Project: SSI\_8862

Given the extent of impact and the poor cost/benefit evidenced within the EIS Cammeray Public School P&C **objects** to the project until such time as:

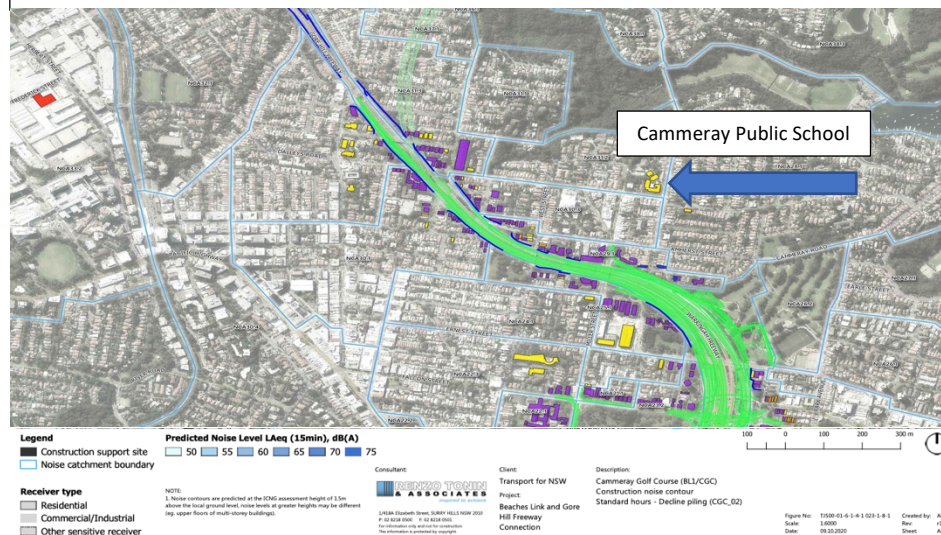
Our school catchment in relation to proposed construction sites (orange):

Appendix G Noise and Vibration Part 2, Annexure N; Receiver building identified for additional operational road traffic noise mitigation with existing noise barriers only (Once built)

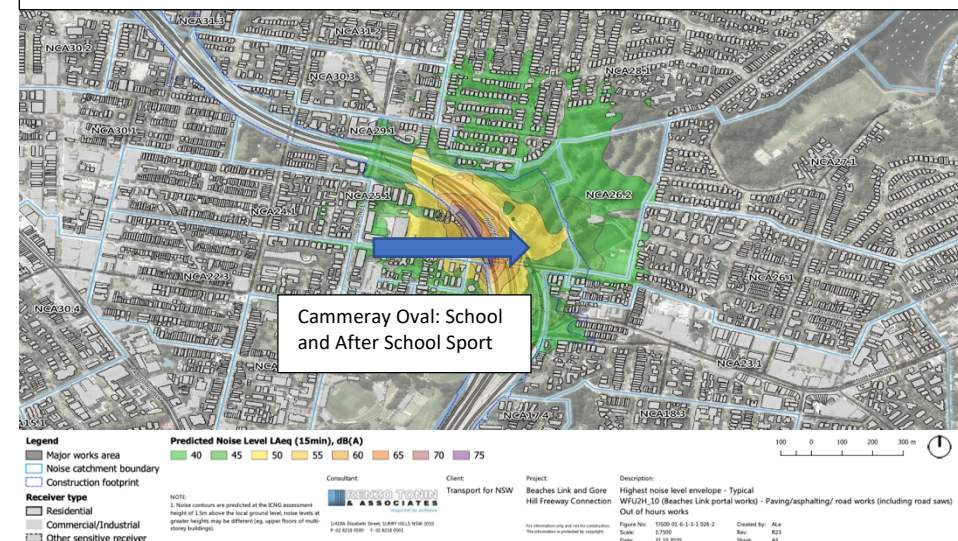
5. **Noise:** The EIS demonstrates that noise will considerably impact Cammeray Public school and it's catchment (NCA 28.1, 29.1, 30.3, 31.1, 31.2, 31.3, 37.1 etc) The area behind the Golf Course and past Green Park will be noise affected throughout the project as will Bicentennial Reserve. Whether children will be able to safely hear and follow instructions while playing sport is unclear. Noise walls and attenuation is needed. Also, the EPA has raised an issue regarding works 24/7 in and around residential areas.

Annual Contour Plot showing dispersion of NO<sub>x</sub> pollutant over the school catchment area

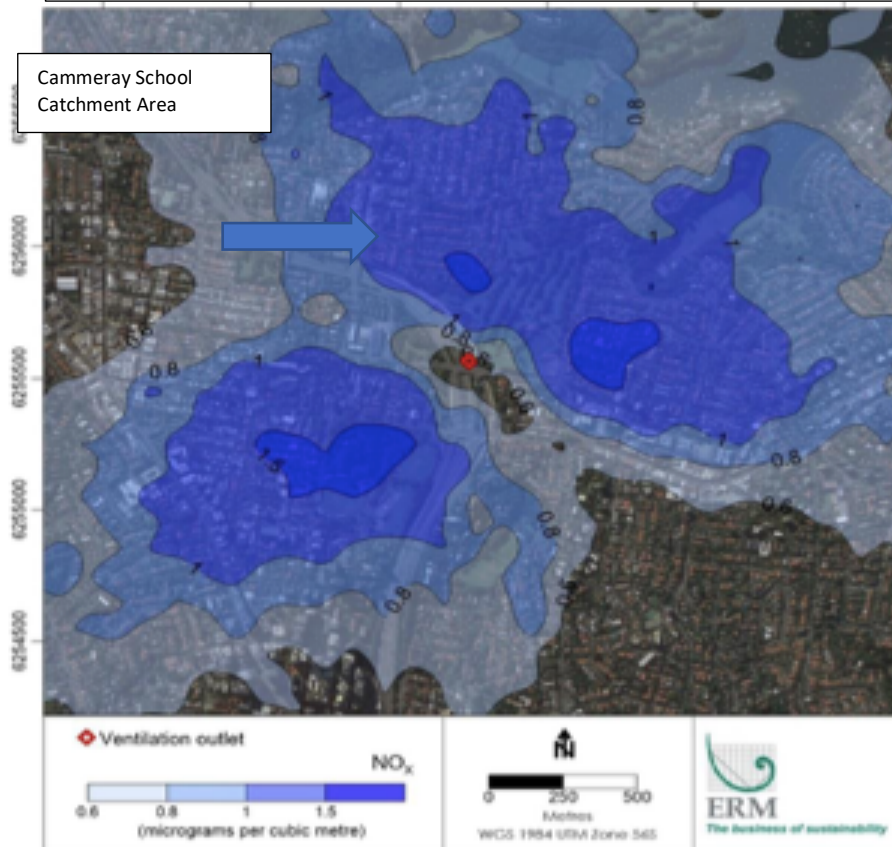
**7. Pollution:** The double ventilation stack at Cammeray will not be filtered. The EIS demonstrates concerning impacts in terms of pollution for CPS and it's catchment. All receivers will experience PM2.5 levels well above national criteria when project opens. Concerningly our local parks will be impacted by increased pollution including Green Park, Cammeray Oval, St Leonard's Park and Bicentennial Reserve. Increased pollution has been modelled (2037) at various community receptor points within our catchment as follows: CR17 KU Pre-School Green Park (CR17)- increased 24hr mean PM 10 & 24hr PM 2.5; CR18 Cammeray Public School (CR18)-increase in 1 hr NO2 & Annual Mean 2.5; CR25 Artarmon Sues Childcare: (Closest point to Willoughby Leisure Centre/ Bicentennial Reserve)- Max 24hr PM2.5 increases which represents the largest increase of 24hr PM2.5 across the project. It is disappointing that a specific CR point was not modelled at Bicentennial & Tunks Parks & local background data was not used ie) Naremburn or Artarmon. Children are most susceptible to pollution, particularly at higher respiration rates. The stacks have no emergency ventilation outlets and so fumes from any high pollution events or emergencies will be dispersed over schools in the area. The EIS confirms that the project will contribute to increased air pollution overall but relies on fuel efficiencies to offset this increase (see Table 8-10). These efficiencies are not yet legislated and a review has been delayed - the project will open before fuel efficiencies are able to be realised. In addition, the sensitivity analysis for CPS demonstrates increased pollution at lower temperatures. Also, the Chief Scientist has raised a question as to whether surface road traffic and induced demand have been sufficiently included in the air quality analysis. Given the evidence and uncertainty the precautionary principal should be employed in an area with such a high density of children. *A letter is attached from the Sydney Children's Hospital regarding the concerns around pollution*

**8. Pollution at Height:** Cammeray Public School sits at height above the double stacks, and it is not clear if a sensitivity analysis has been completed to assess the impact of this. The EIS identifies buildings 300m away will receive an unacceptable risk of pollution and that more work needs to be done to establish risk at height over greater distances. We would like clarification of Cammeray Public Schools additional pollution risk given it's relative height to the stack.

Appendix V: UDLCVIA. Stack Field of Visual Influence (Yellow). Cammeray Public School and the majority of it's catchment will see the stack once built. Many Naremburn families will be able to see the Artarmon Stack.

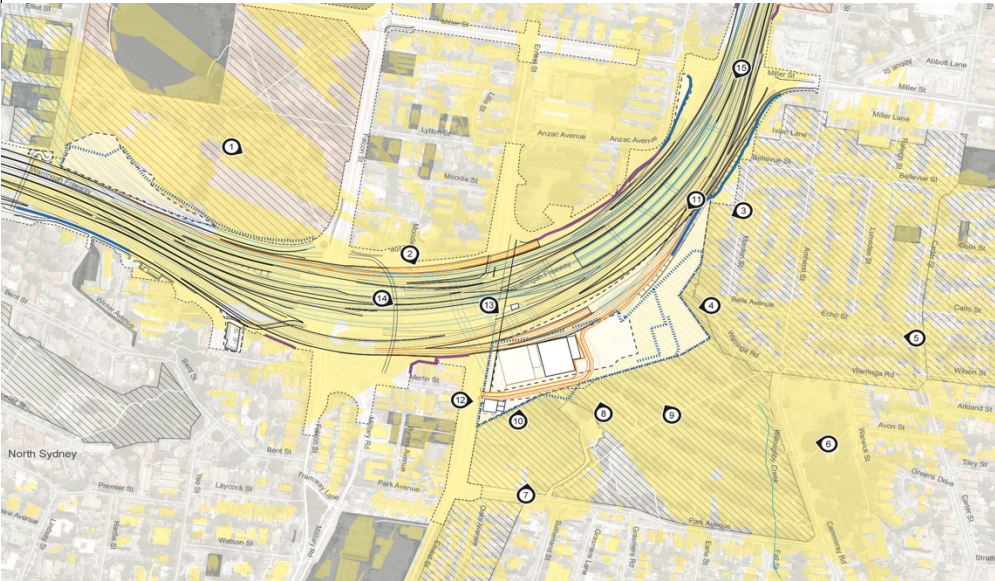
**11. Visual Amenity:** the stack can be seen from a long distance (see map below). Most of Cammeray will be able to see the stack once built which degrades visual amenity and may affect house prices creating financial stress at a difficult time for many families post Covid.

## Crystalline Silica and Contaminated Dust Risks and Proximity to Children

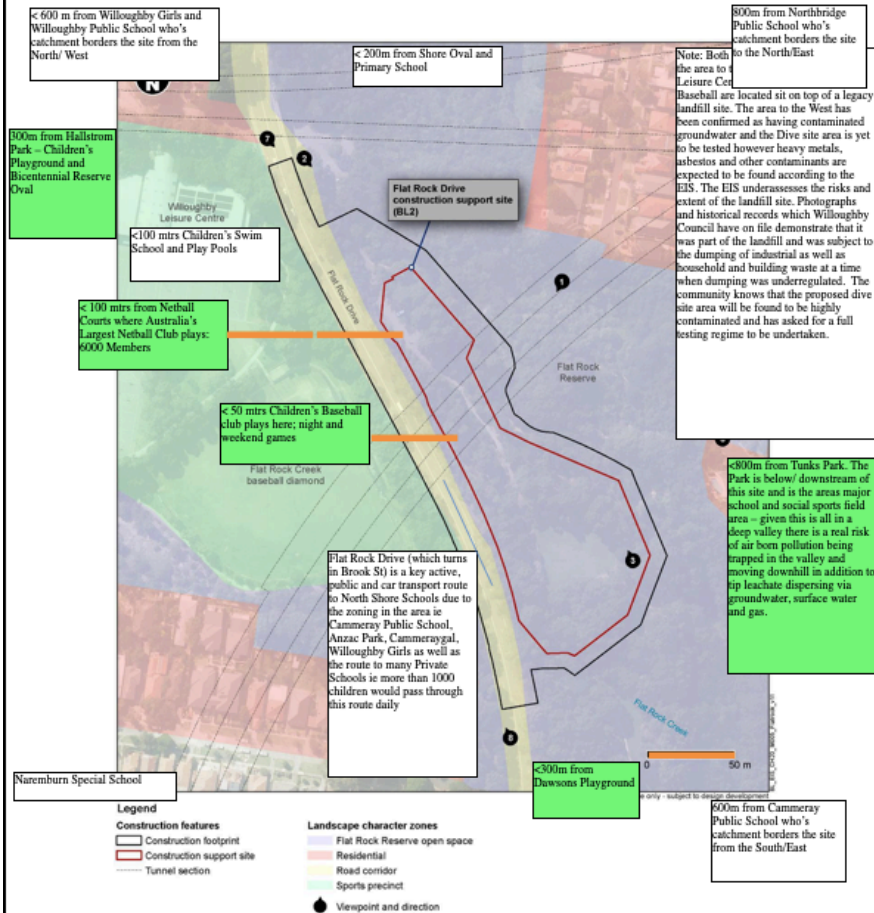
1. **Dust:** Dust risks have been assessed as moderate to high in the EIS for CPS, it's families and parks. Dust is known to negatively impact children's health and of particular concern is dust released from the Cammeray Golf Course Site, along the Warringah Freeway & at Flat Rock which will likely contain Silica and/or be contaminated. This was raised during the WHT EIS but the Beaches Link EIS confirms that contamination testing is not yet complete. The EIS also states that dust risks cannot be fully controlled. Our school, homes and sports fields (Cammeray Park, Tunks Park, Bicentennial Reserve) will likely be impacted limiting our children's ability to play sport during the 5 years of construction works for the WHT and an additional 2 years for BL. 4500m3 of spoil is allowed to be stockpiled outside of sheds at Cammeray & 500m3 outside at Flat Rock

Traffic Volumes on Military Rd stay at today's level  
after building the tunnel

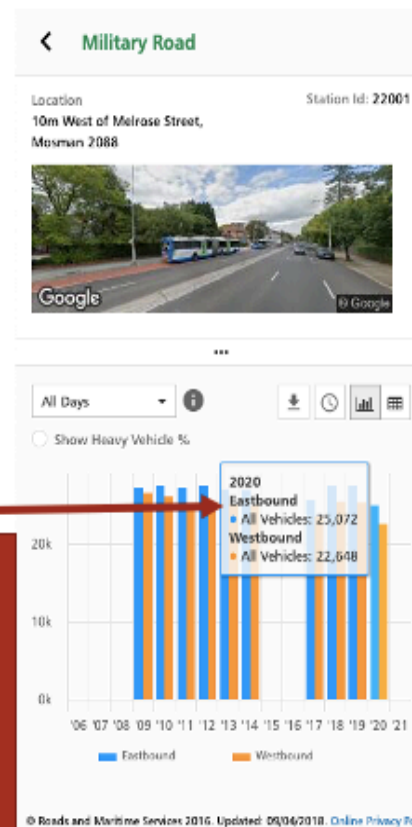
2. **Project justification:** The traffic levels on Military Rd do not reduce from today's levels as a result of the project which was a main aim of the project. The 10% reduction claim is based on a future predicted growth in traffic rather than today's level so there are no tangible improvements to the local area.

The traffic numbers  
in future AFTER  
Beaches Link is built  
are the same as  
current numbers  
and building the  
tunnel only  
achieves a 10%  
decrease on FUTURE  
predicted traffic
